Service Bulletin

Category T	Applicable Model/s 1995-97 Millenia	Subject BLOWER MOTOR FAN SPEED INCORRECT BLOWER MOTOR INOPERATIVE	Bulletin No. 002/97
			Issued 03/10/97
			Revised

1995 - 97 Millenia

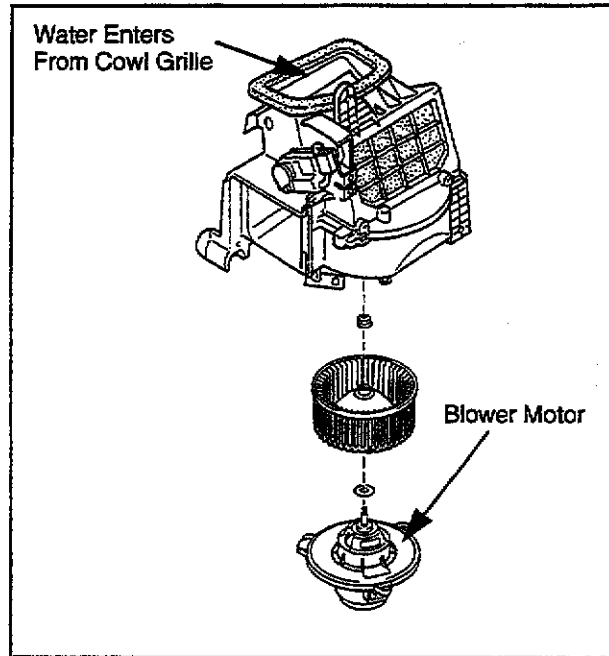
The blower motor fan speed may be incorrect or the fan is inoperative. This is caused by corrosion on the blower motor shaft created by water entering the air ducts and traveling to the blower motor from the blower motor casing.

To prevent water from entering the blower motor assembly, sealant is applied during production. Customers complaining of this concern should have the vehicle inspected and if necessary, repaired according to this bulletin.

1. Verify the concern.
2. Replace the blower motor assembly with a modified part.
3. Inspect the power transistor for proper operation. Refer to section U of the workshop manual.
4. Verify repair.
